Proposal #04: 4085-62-71, WISC 2023005
City of De Pere, Greenleaf Road
STH 32 Northbound over CTH PP
STH 32
Brown County

Letting of October 11, 2022

This is Addendum No. 02, which provides for the following:

SHEET: 16

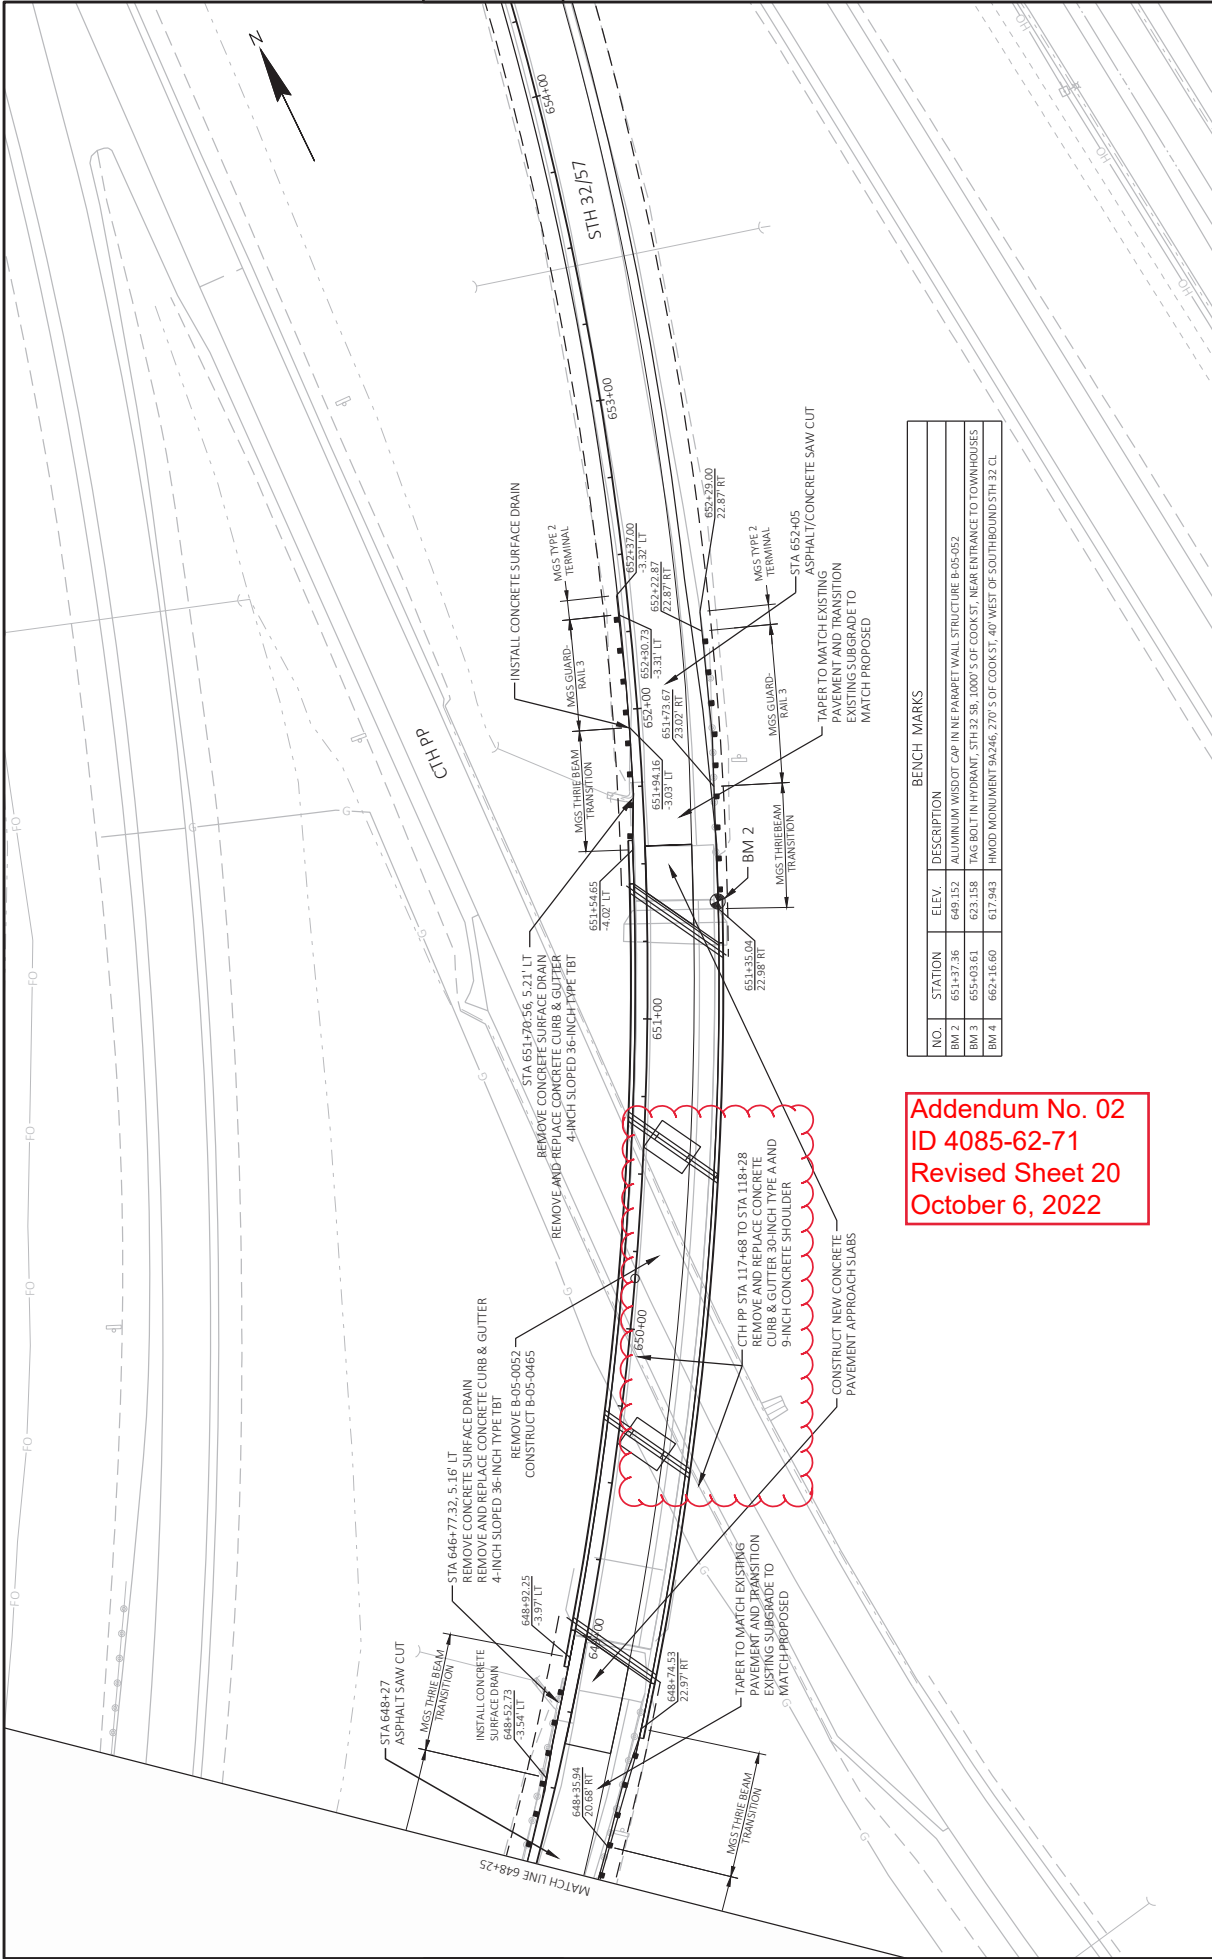
Revised Plan Sheets	
Plan Sheet	Plan Sheet Title (brief description of changes to sheet)
15	Miscellaneous Quantities – Updated quantities in Removals table
16	Miscellaneous Quantities – Updated items and quantities in Pavement and Curb & Gutter tables
20	Plan Sheets – Added callout noting removal and replacement of existing curb & gutter and shoulder on CTH PP
22	Standard Detail Drawing 08D01
29	Standard Detail Drawing 13C09
